CITY OF SACRAMENTO

SUBJECT: 1. Negative Declaration
2. Subdivision Modification to create substandard lots
3. Tentative Map (P-9422)

LOCATION: 600 feet southeast of Riverside Boulevard and
13th Avenue

RESOLUTION No. 81-586

PLAT OF PARK ESTATES

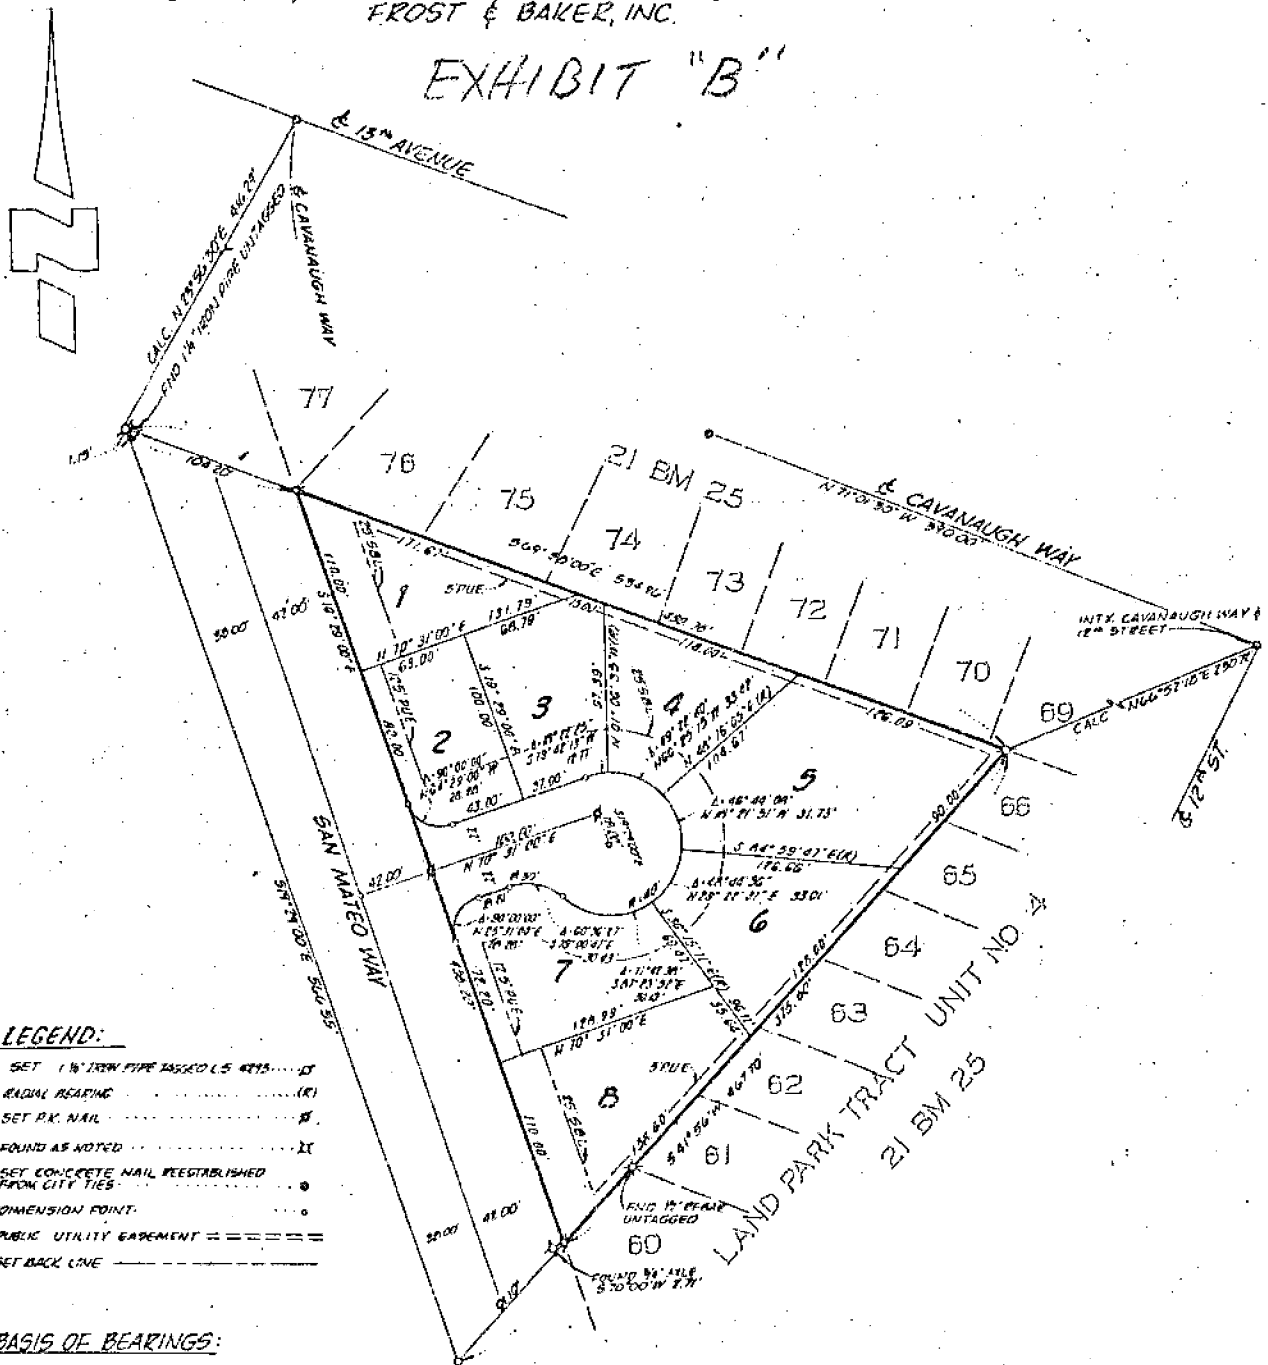
1. In reference to the variance/subdivision modification, the applicant is proposing to create one lot with less than 100 feet in depth. Staff has no objection to this request because the site is an irregular shaped lot which makes it difficult to meet all requirements of the Subdivision Ordinance.

2. The subject site is a landlocked parcel and surrounded on three sides by existing single family development. At the present time access to this site is via a piece of City-owned property. The applicant is proposing to construct a street on the City's property which will connect the subject site and Riverside Boulevard. The street will have to be designed with a 50 foot right-of-way section; however, sidewalks will be required on the east side only. The curb to curb width is 36 feet. The 36 foot curb to curb is necessary because there is a baseball park located south of the subject site and access to this park is also along the City-owned property. Vehicles utilize the City property for parking during usage of this ball park, and it is anticipated that the proposed access street (San Mateo Way) will be utilized for parking.

3. The proposed use of the site is compatible to surrounding land uses. There are existing single family dwellings to the north, south, and east. There are several lots which are irregular in shape, however, it is unavoidable in this case because of the triangular shape of the site.

- a. Provide standard subdivision improvements as specified in Section 40.811 of the subdivision ordinance prior to filing the final map;
- b. Improve San Mateo Way from Riverside Boulevard to subject site with 36 feet from curb to curb and sidewalks on easterly side prior to recordation of the final map (off-site improvements required);

- c. Prepare a sewer and drainage study for review and approval of the City Engineer prior to filing of the final map;
- d. The applicant shall pay in-lieu fees pursuant to the Parkland Dedication Ordinance (No. 81-007) prior to the finling of the final map. The applicant shall submit an appraisal of the property to the City within ninety (90) days of filing of the final map (Section 40.1306b, 40 1313c);

GRADING PLAN FOR:
PARK ESTATES

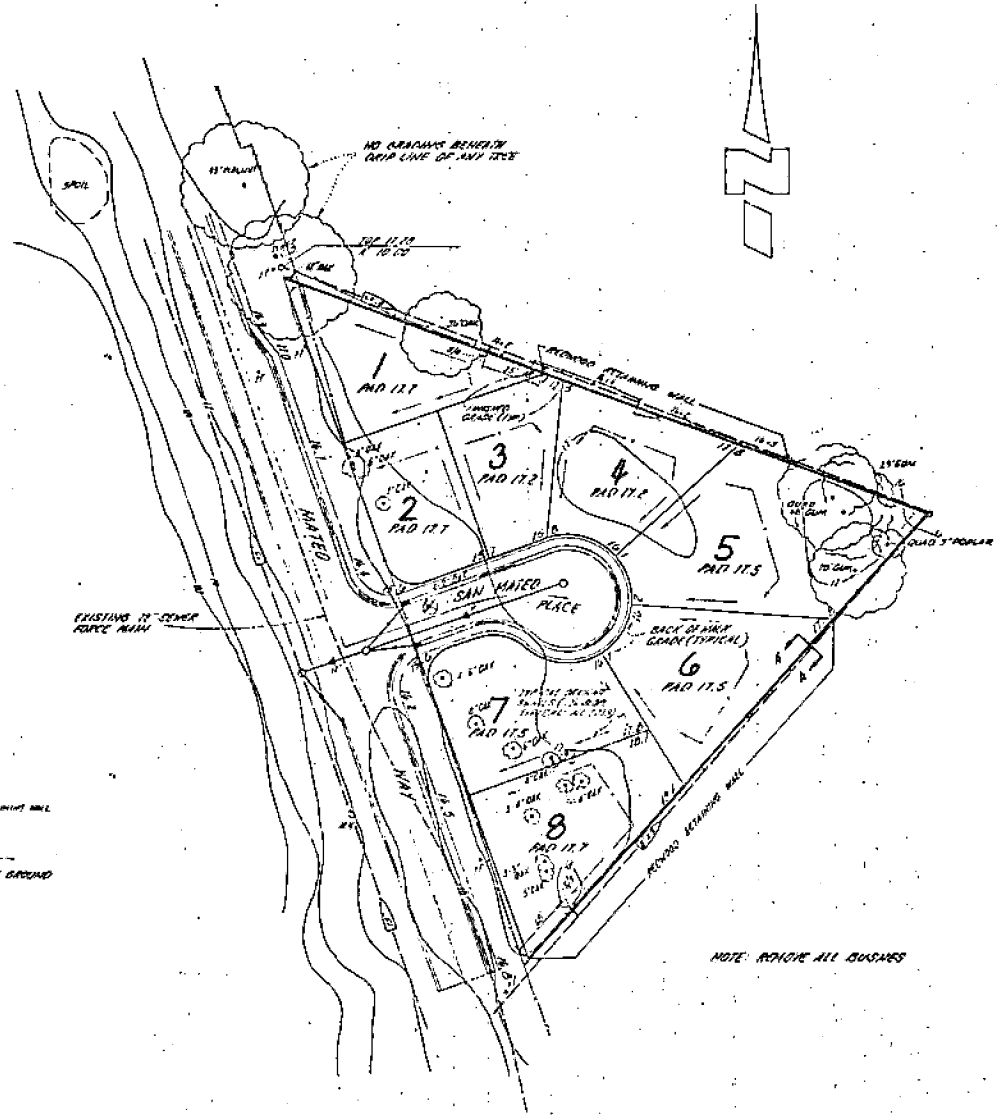
5. The staff has noted a significant number of trees throughout the site and determined that retention of all but one is feasible. There is only one tree in the proposed street right-of-way. Staff suggests that the remaining trees be retained.

- e. The following trees shown on the grading plan shall be retained unless it is determined by the City Arborist that the tree(s) is diseased or not significant:

- 2 - Heritage trees located north and just off-site along the east side of San Mateo Way. The applicant has jogged the road alignment of the access road (San Mateo Way) to avoid the drip lines of these trees;

- 2 - Oaks on Parcel 1
 - 3 - Oaks on Parcel 2
 - 3 Gums, 1 Poplar on Parcel 5
 - 5 - Oaks on Parcel 7
 - 4 - Oaks on Parcel 8
- f. There shall be no grading (fill or removal) parking, or storage of vehicles or construction materials within the drip line of the specified trees, in order to assure there will be no spills, compaction, etc. that could be detrimental to the trees.

Removal of any bushes, as noted on grading plan, shall not disturb the above mentioned trees or their root systems.
